Application for Planning Approval

DA2026/022

39A ANDREW STREET, BRIGHTON

MULTIPLE DWELLINGS (1 EXISTING, 34 NEW) & ASSOCIATED INFRASTRUCTURE

7 SUN SHADOW DIAGRAM_1500PM
Scale 1:600

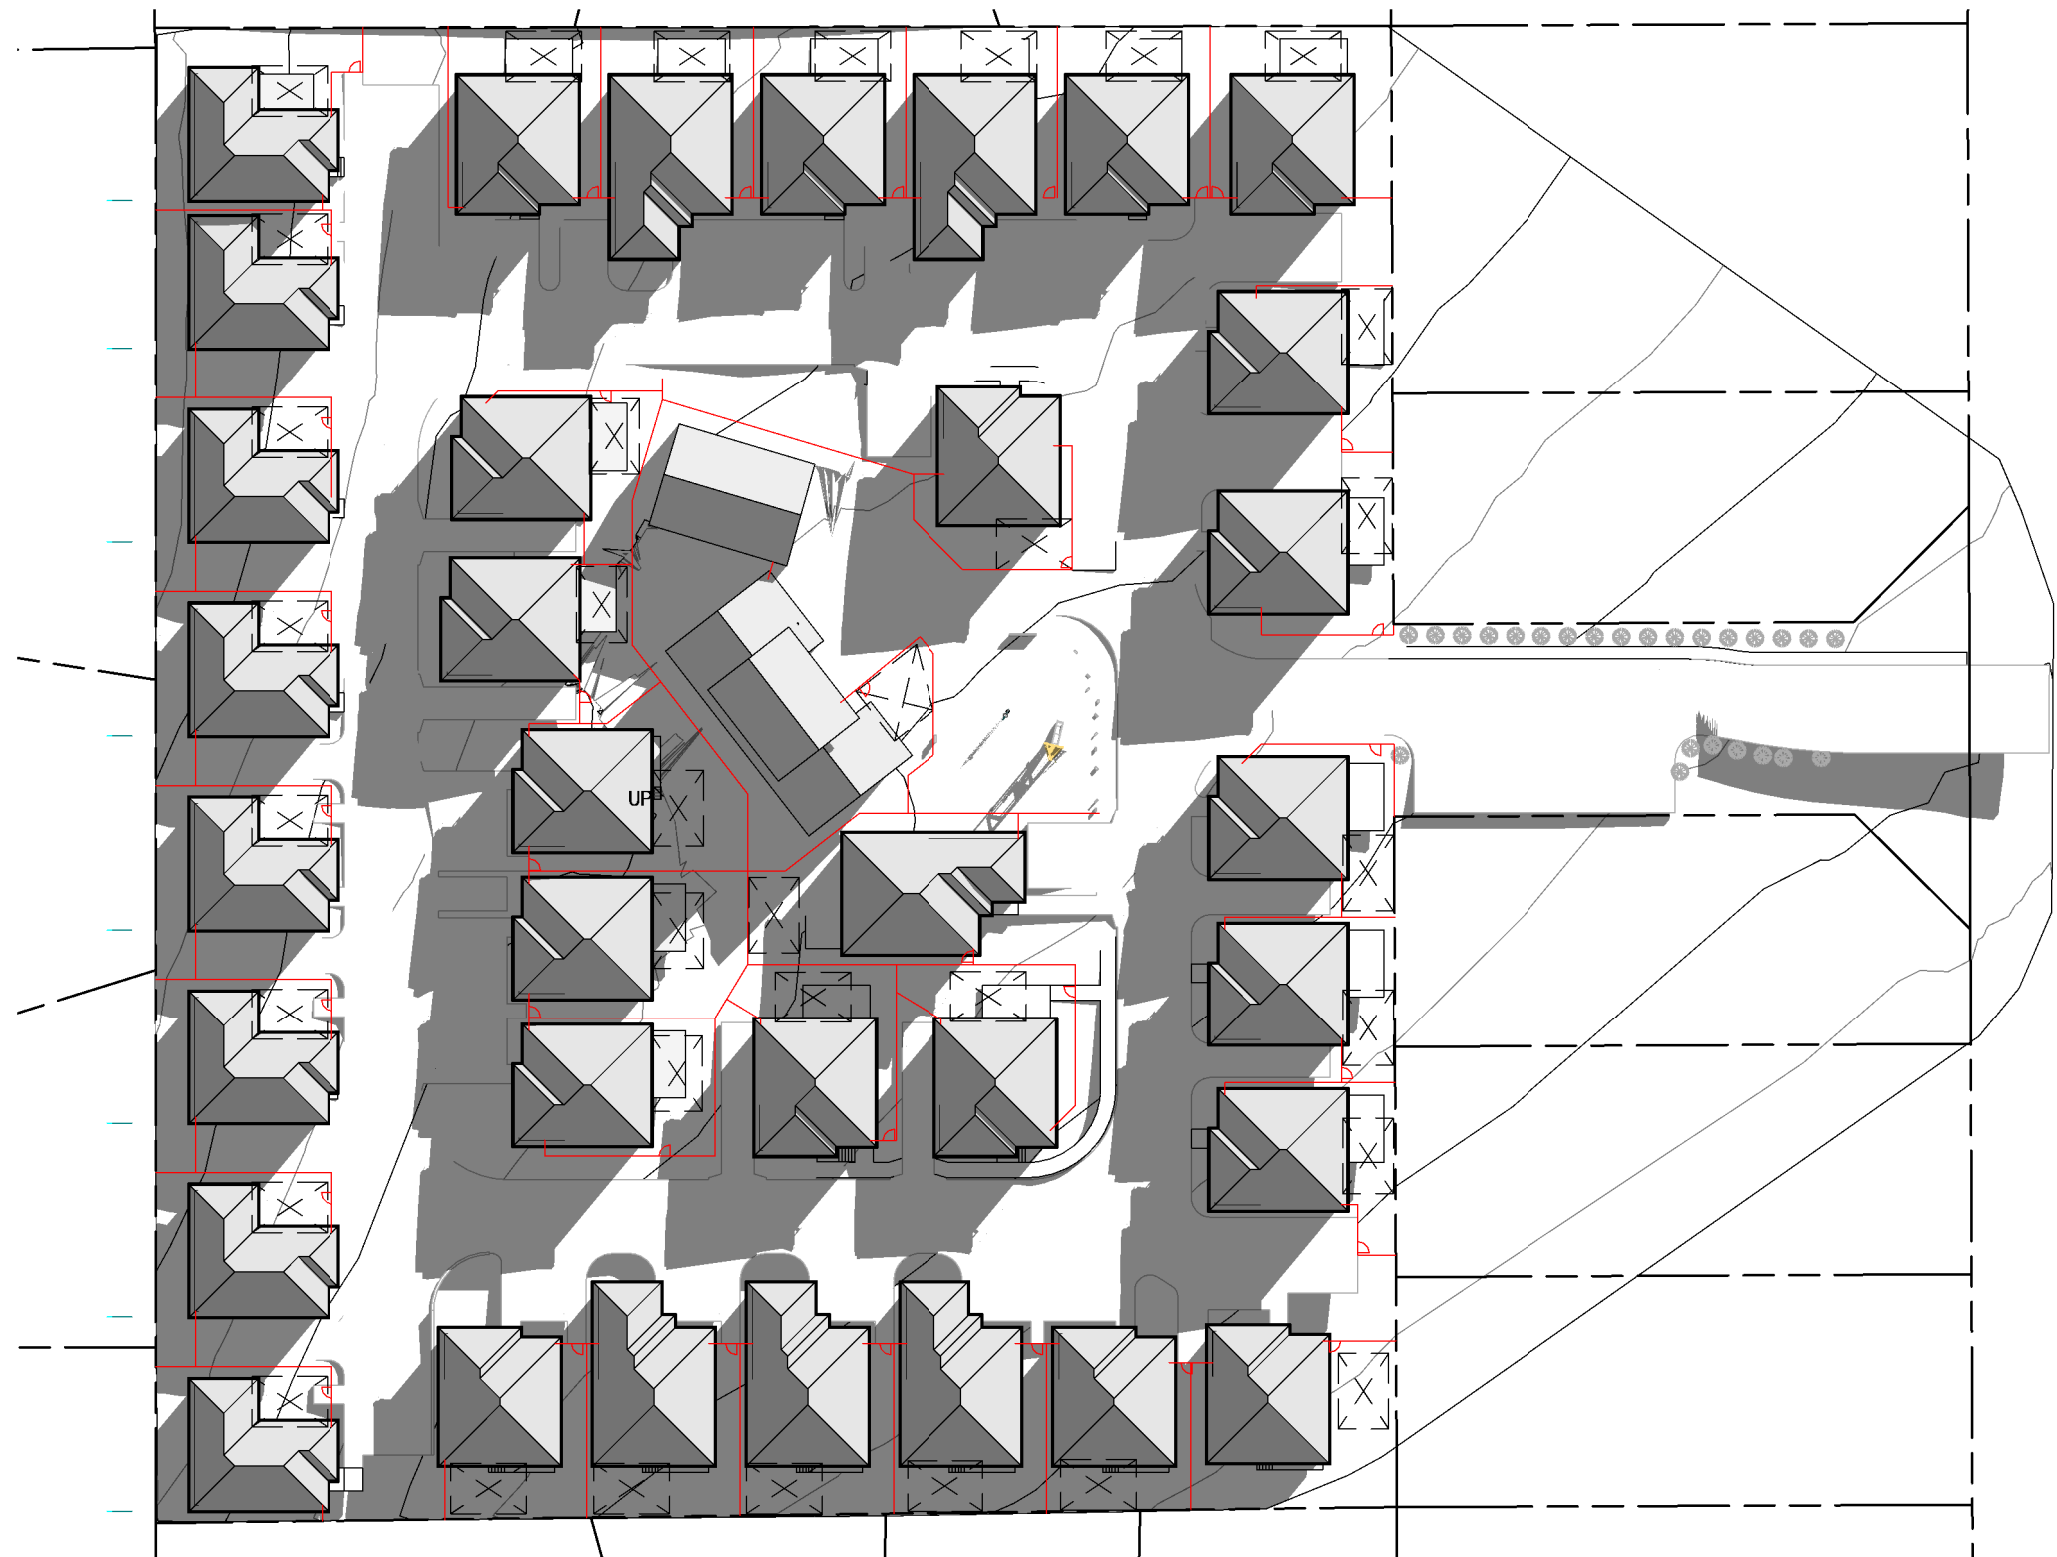
Please provide a planning report addressing each of the development standards, and where the proposed application does not satisfy the acceptable solution (eg 8.4.2 A1; 8.4.2 A3; 8.4.4 A1), include a written response to the performance criteria.

8.4.4 – A1 – The shadow diagrams provided in Drawing DA20 demonstrate that all proposed units (POS) will receive a minimum of 3 hours of direct sunlight between 9:00 am and 3:00 pm on 21 June. Accordingly, the proposed development satisfies the requirements of Acceptable Solution 8.4.4–A1(b).
